Subject: New Touch Controller Board for the D22/D25 LCD Displays

D22/D25 Touch Controller Upgrade

Fujitsu Transaction Solutions	FIELD CHANGE AUTHORIZATION	FCA-08-008
	Sustaining Engineering		EC-14974
	San Diego, CA; Montreal, QC		June 06, 2008

KD20049-B81X Touch Controller Board Rev 003AB or above

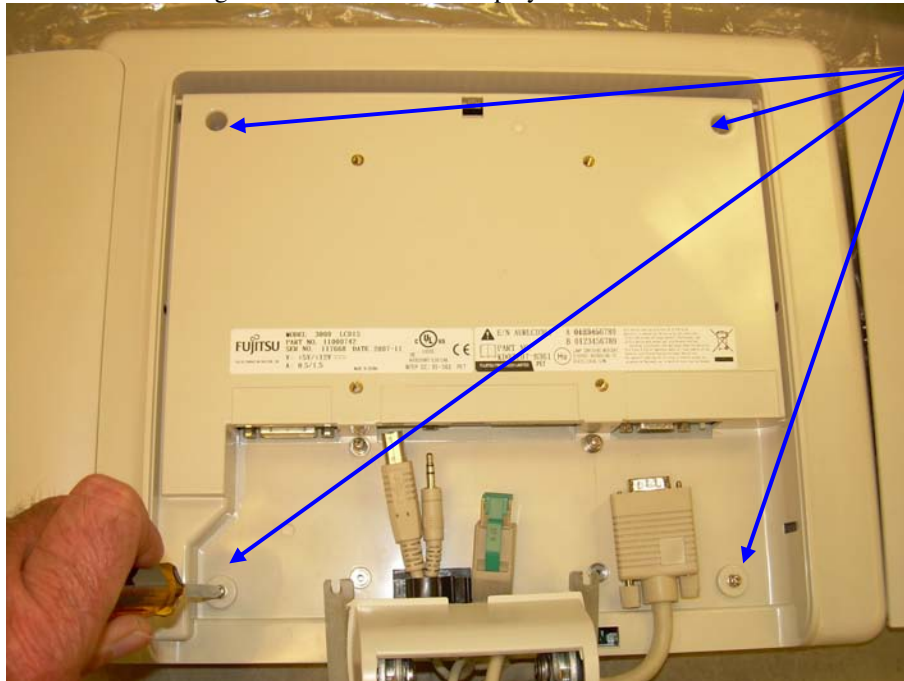
This new Touch Controller board is being released and made available to the field to correct an issue where the touch functionality would intermittently be lost. Usually this condition is recovered by resetting the powered USB cable or a restart of the terminal. Replacing the Touch Controller board with this new version will correct the condition.

The Touch Controller PWA in the D22/D25 display has been updated to correct this issue.

Field replacements will be on a fit-on-fail basis. If a terminal has an intermittent Touch issue, this board should be replaced. All boards purchased for spares/repair are at or above the revision level above.

All Displays returned for repair should have this board replaced.
